☒ Oil Well ☐ Gas Well ☐ Other8. Well Name and No.  
GLOW WORM ALX FEDERAL 122. Name of Operator  
EOG Y RESOURCES INCContact: KAY MADDOX  
E-Mail: Kay\_Maddox@EOGRESOURCES.com9. API Well No.  
30-015-35314-00-S13a. Address  
104 S 4TH STREET  
ARTESIA, NM 882103b. Phone No. (include area code)  
Ph: 432 686 3658 CONSERVATION  
ARTESIA DISTRICT10. Field and Pool or Exploratory Area  
LOS MEDANOS-DELAWARE

EOG PROPOSES TO PLUG THIS WELL USING THE ATTACHED PROCEDURE. CURRENT AND PROPOSED WELLBORES ARE ALSO ATTACHED.

Glow Worm ALX Federal #12 – P&A

**Permanent Abandonment of Federal Wells  
Conditions of Approval (LPC Habitat)**

**Proposed Wellbore Diagram:**

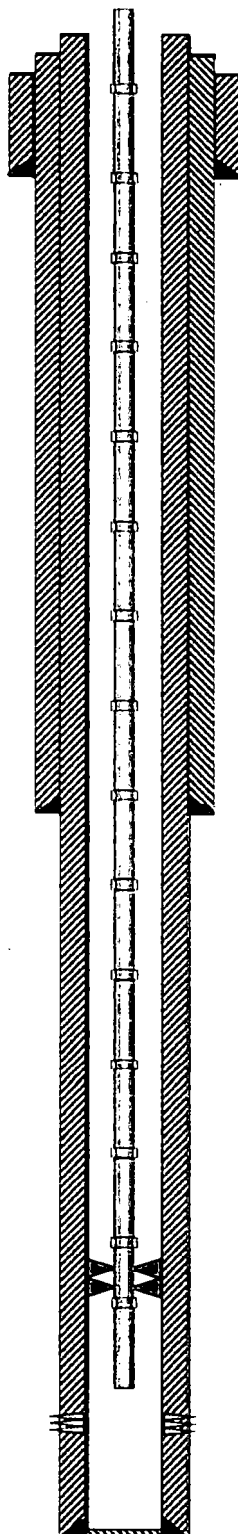
*R-111-P. Solid Plug from 4054-800.  
Can pump in stages. Tagging prior to  
each stage.*

Sol: d plug  
 4054-800  
 Tag

*" R-III-P Potash "**Solid Plug 4054-800.**GC 3/13/19  
Accepted for record - NMOCD*SEE ATTACHED FOR  
CONDITIONS OF APPROVAL*Below ground level dry hole marker required*
